BID MEMO 01

<u>Saints - Cafeteria & Viewing Area</u>

REVISION #01

New Orleans Saints Viewing Area and Cafeteria Expansion 5800 Airline Drive Metairie, Louisiana 70003

2 Section 82 A4.07 1/2" = 1'-0"

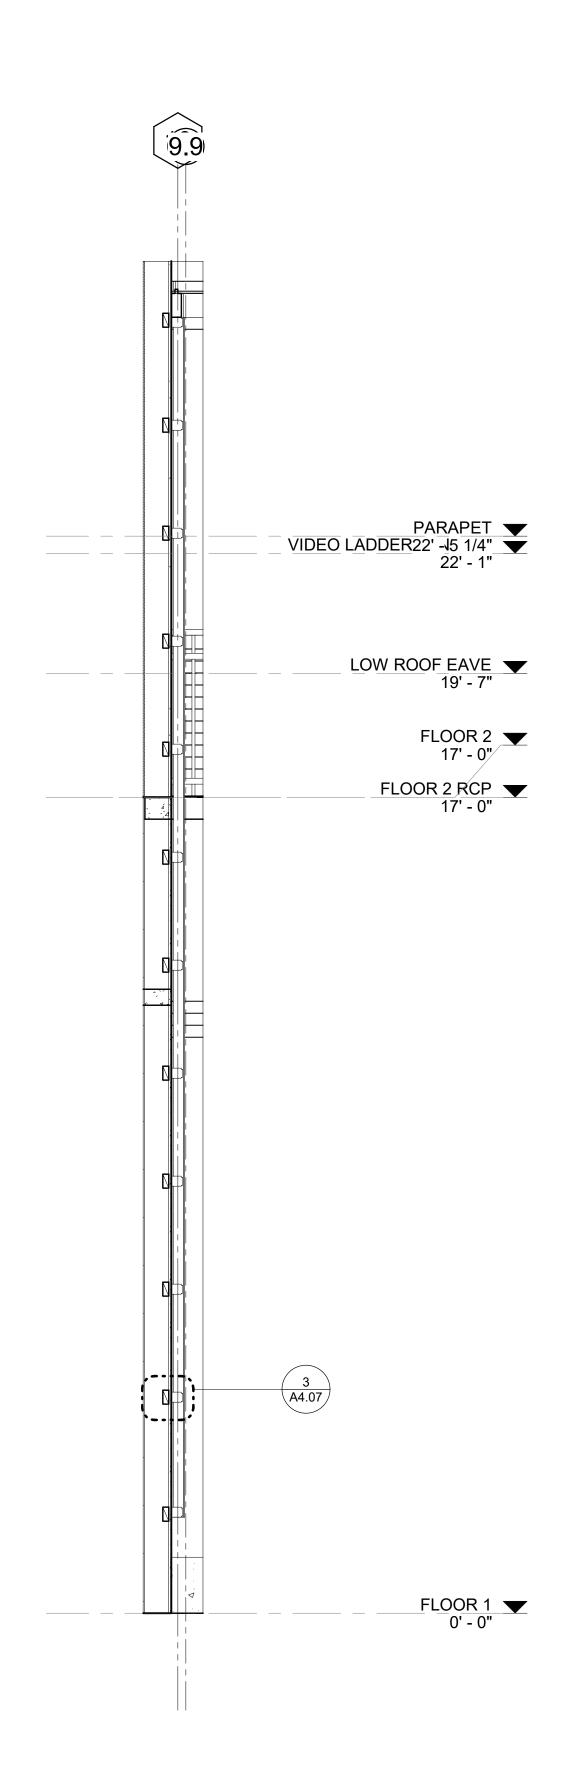
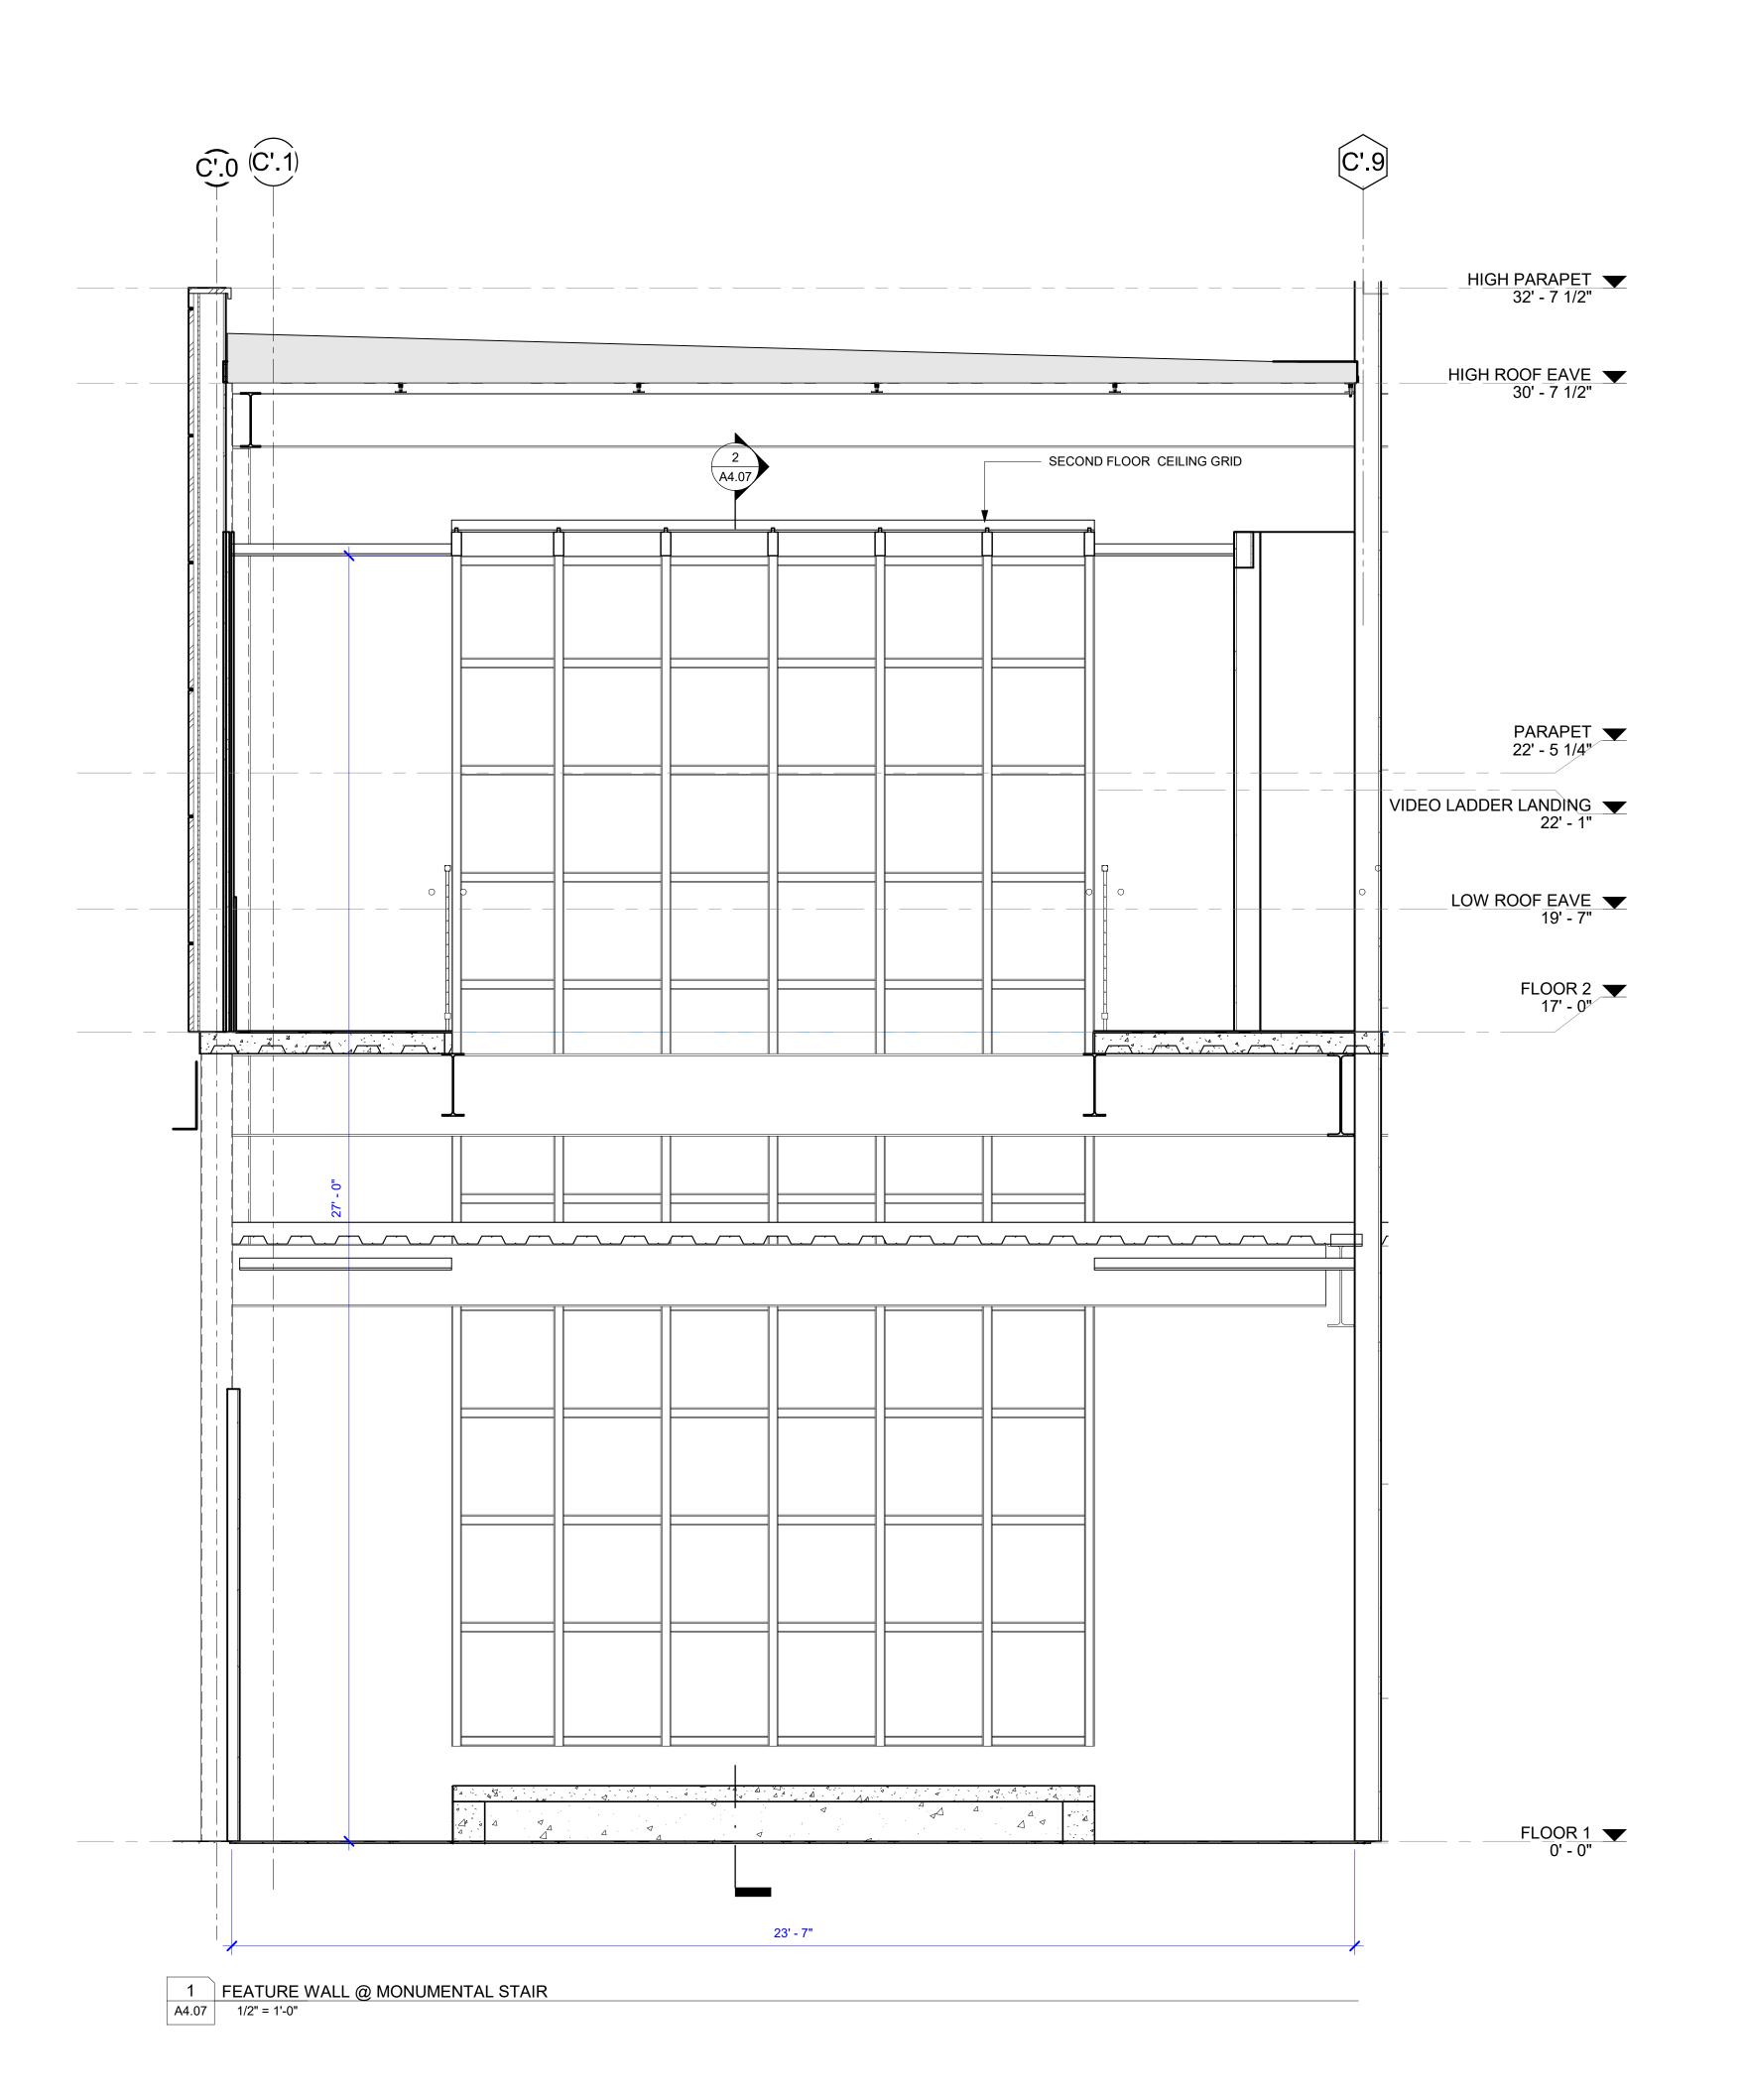
- Graphics fixed at elevator pit- A4.06
- Revised feature wall details at monumental stair A4.07
- Parapet roof details revised showing louver and post over structural beam condition A5.10

DRAWN BY | WDG A5.11

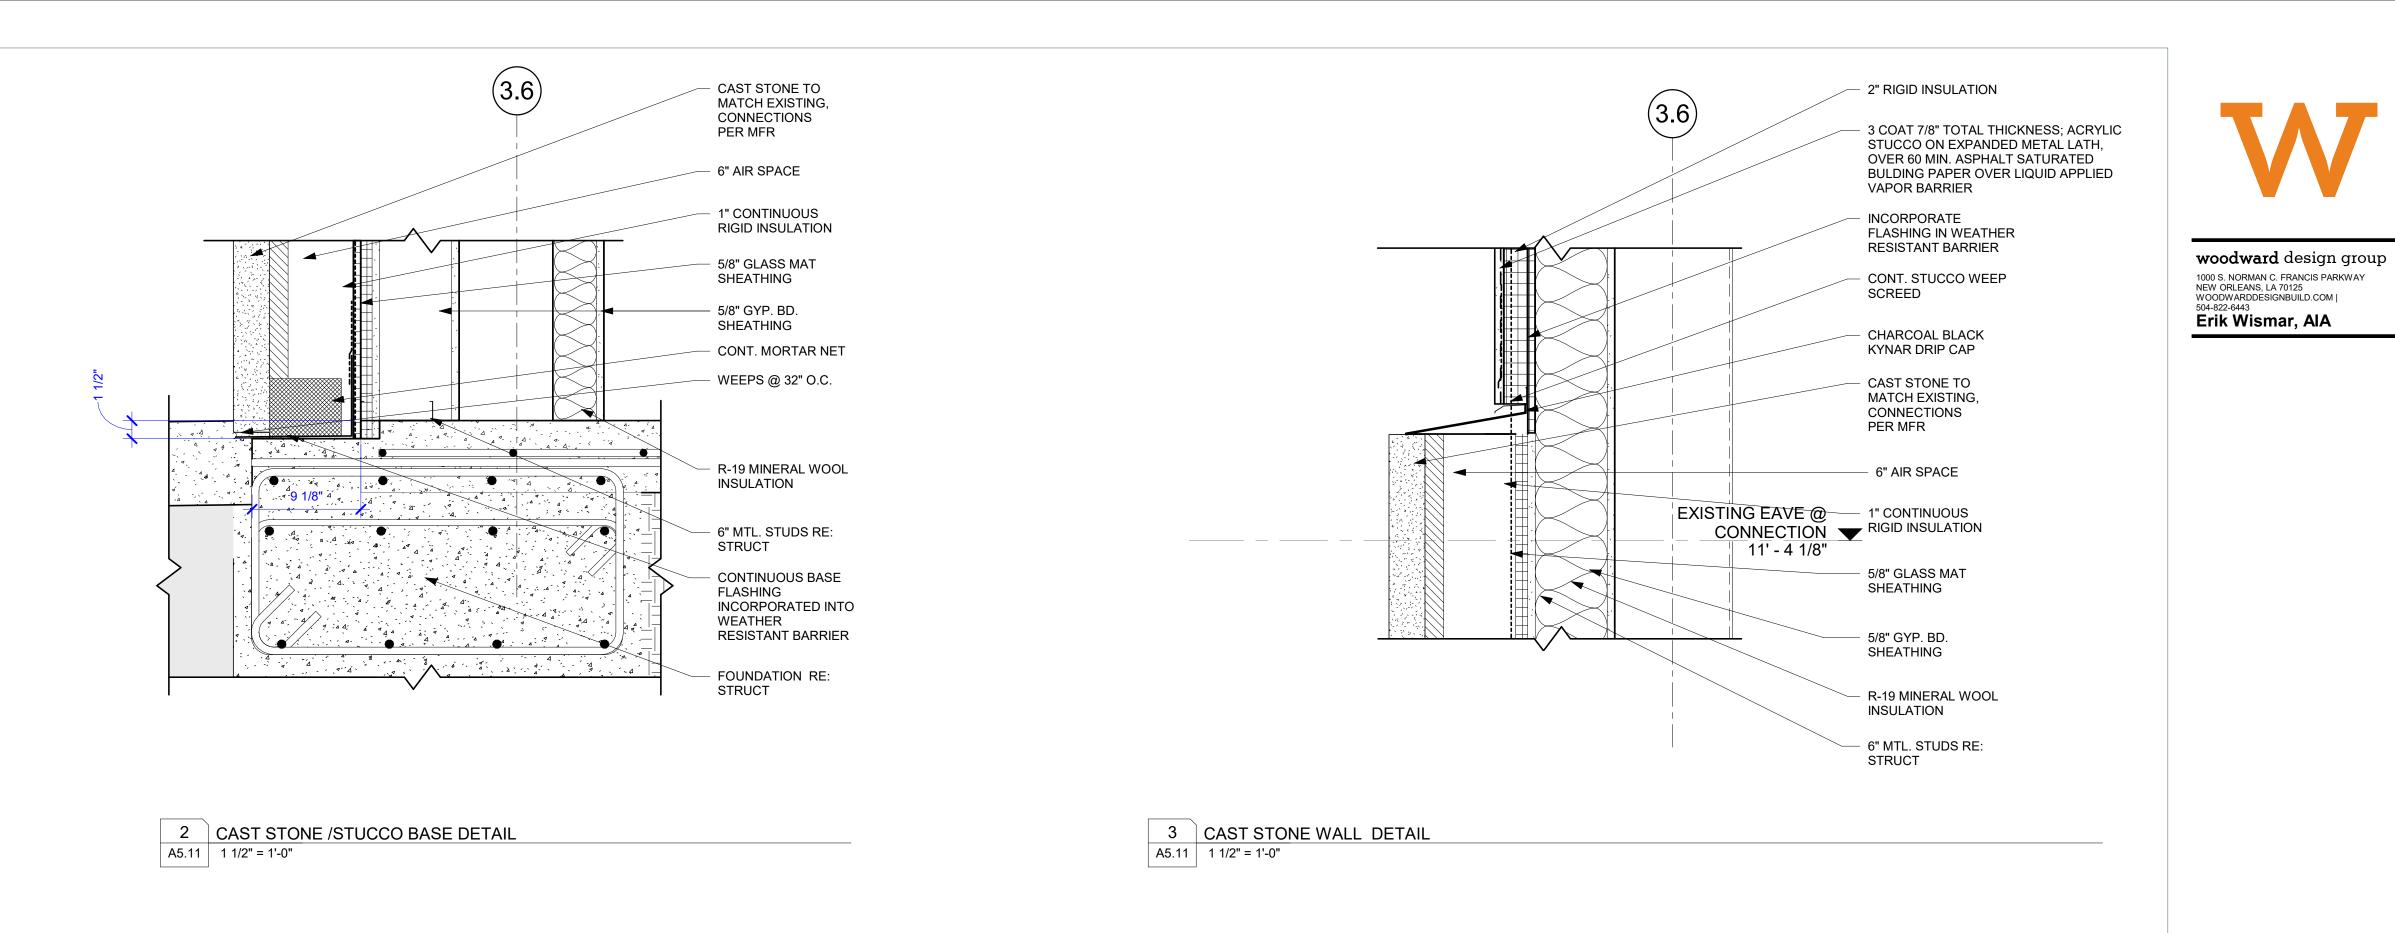
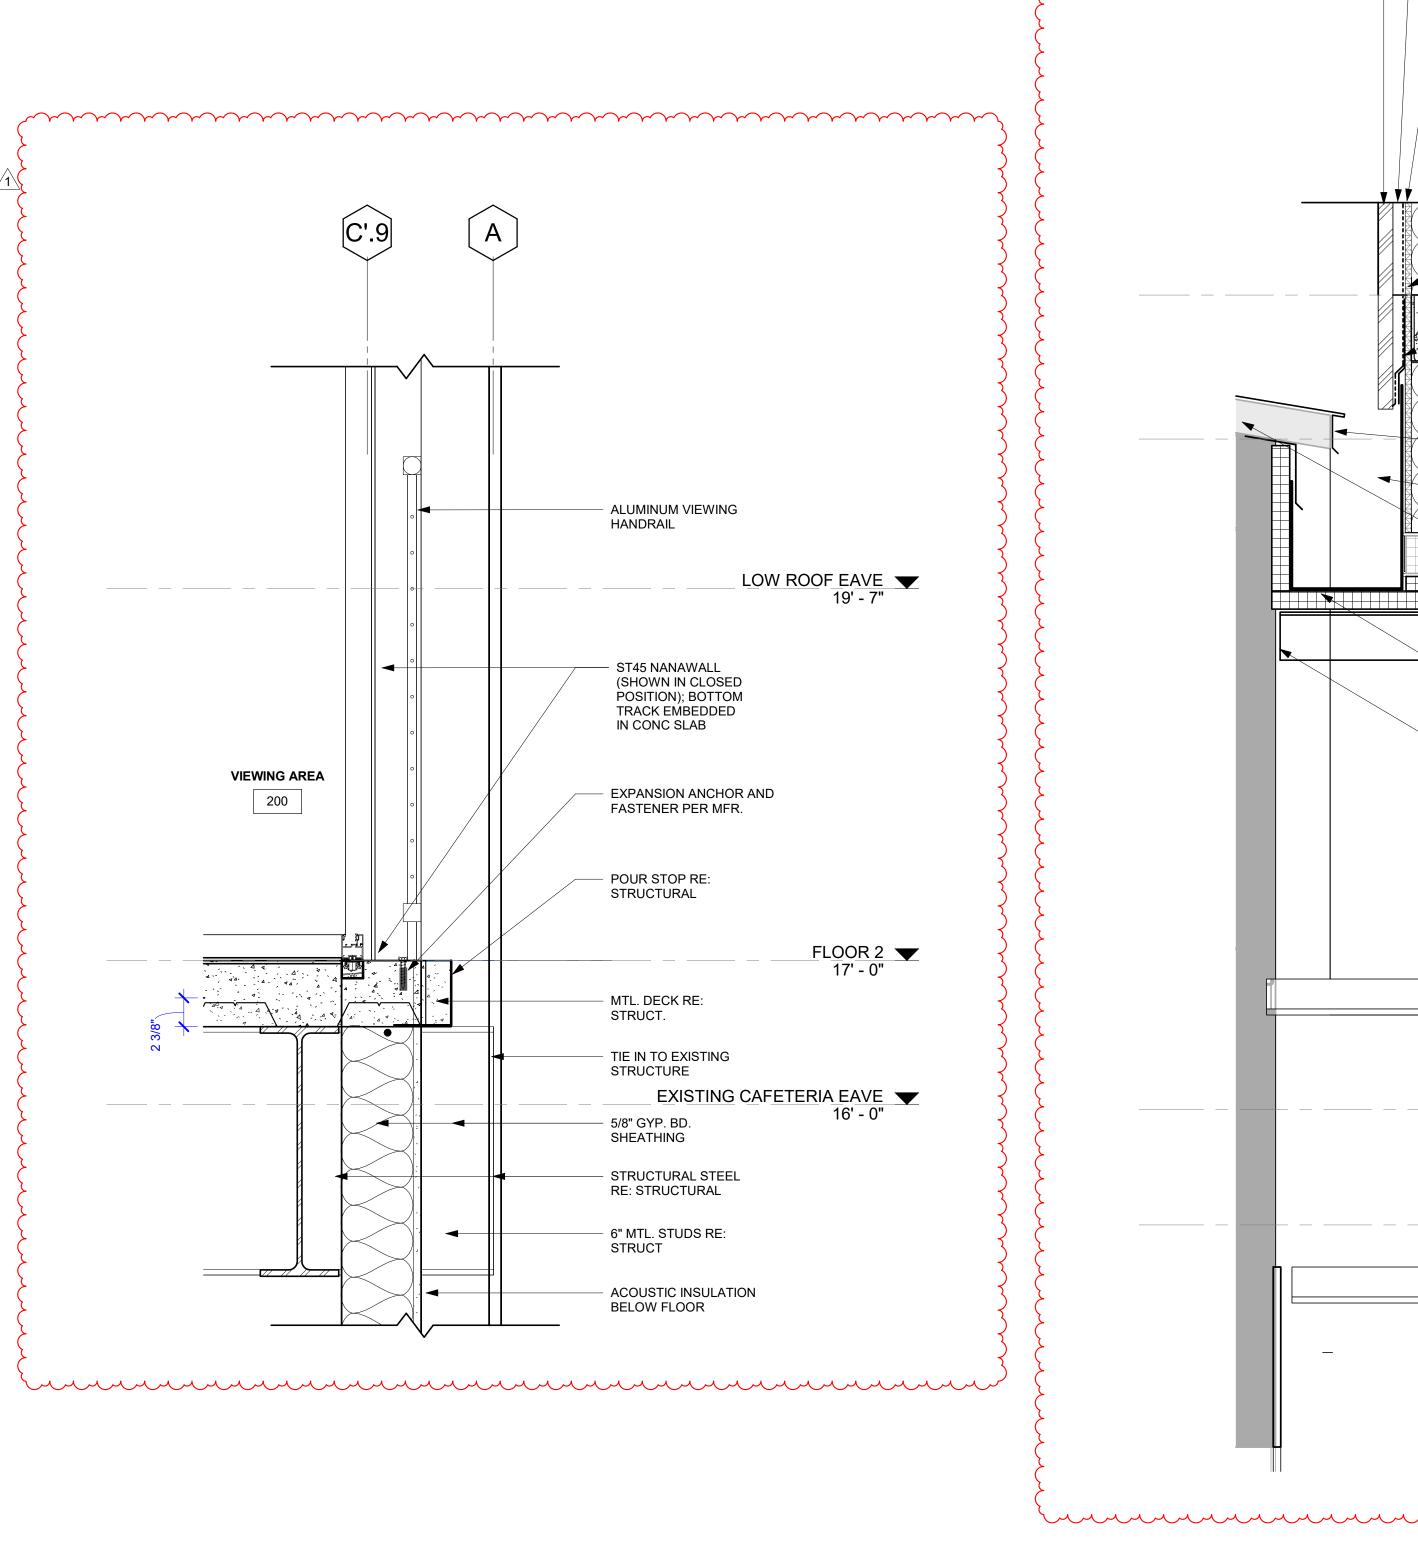
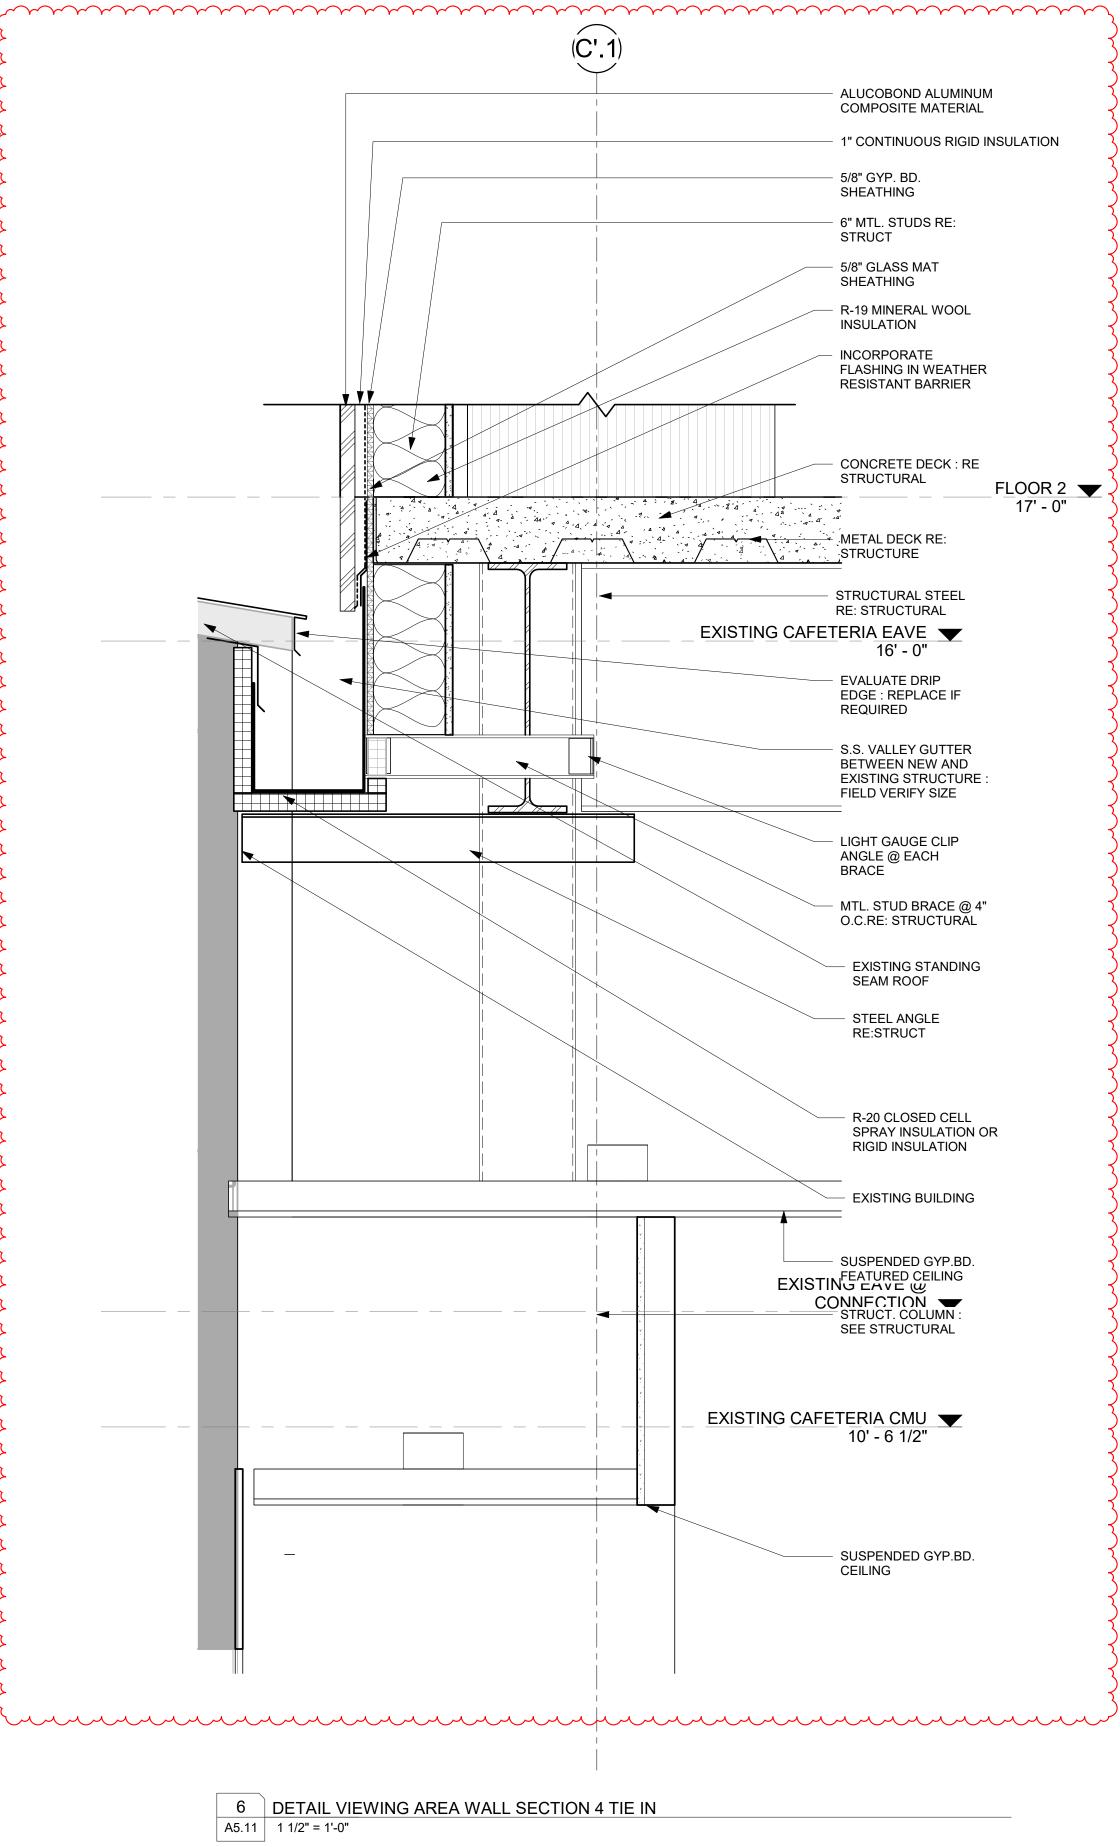
- Guardrail detail revised at view area 200 & valley gutter detail showing steel angle support A5.11
- Revised viewing area guard rail details A6.31
- Plastic laminate color identified on room finish legend. Wall tiles and floor tiles colors were identified for restrooms - A6.50
